RENESAS TECHNICAL UPDATE

Product Category	MPU/MCU		Document No.	TN-RZ*-A003A/E	Rev.	1.00
Title	RZ/A Series: Notes about Power-Down Modes		Information Category	Technical Notification		
Applicable Product	See following	Lot No.	Reference Document	See following		
		All

In RZ/A1H Group, RZ/A1M Group, and RZ/A1L Group, a bug about Power-Down Modes is found.

[1] Condition

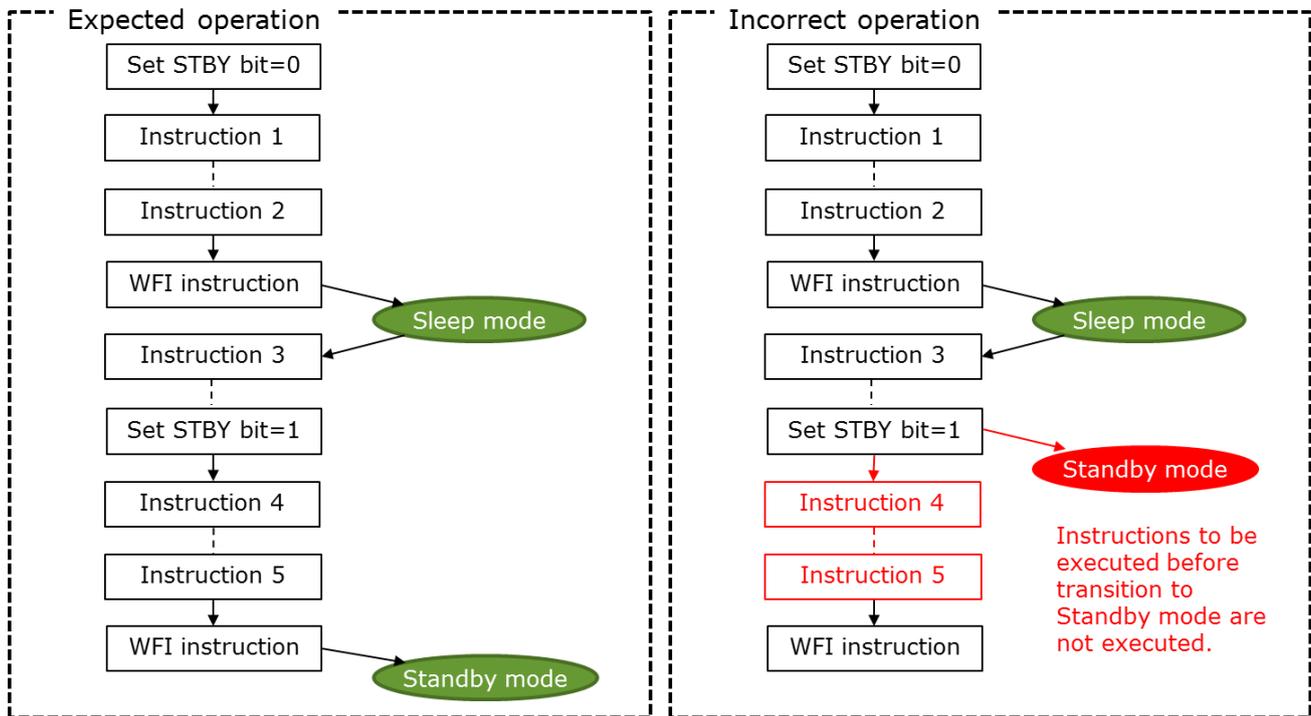
If both of following two conditions are satisfied when Power-Down Modes is used.

- 1) Both "sleep mode" and "software standby mode or deep standby mode (referred as "standby mode" if there is no need to distinguish two modes)" is used.
- 2) WFI instruction is used to transition to the sleep mode.

There is possibility that the transition to the standby mode happens before execution of expected instructions, which is placed after the instruction which set 1 to STBY bit of STBCR1 register.

- (A) Use "SEV instruction, WFE instruction x2" instead of "WFI instruction" In transition operation to sleep mode. And ARM CPU register must be set unmask the interrupt corresponding to cancelling source, because there is functional difference between WFI instruction and WFE instruction. When WFI instruction is used, the interrupt can be masked because sleep mode cancelling is executed regardless of the interrupt mask. When WFE instruction is used, the interrupt cannot be masked because it also masks sleep mode cancelling.
- (B) Place the instruction, which changes STBY bit of STBCR1 register from 0 to 1, immediately before WFI instruction.
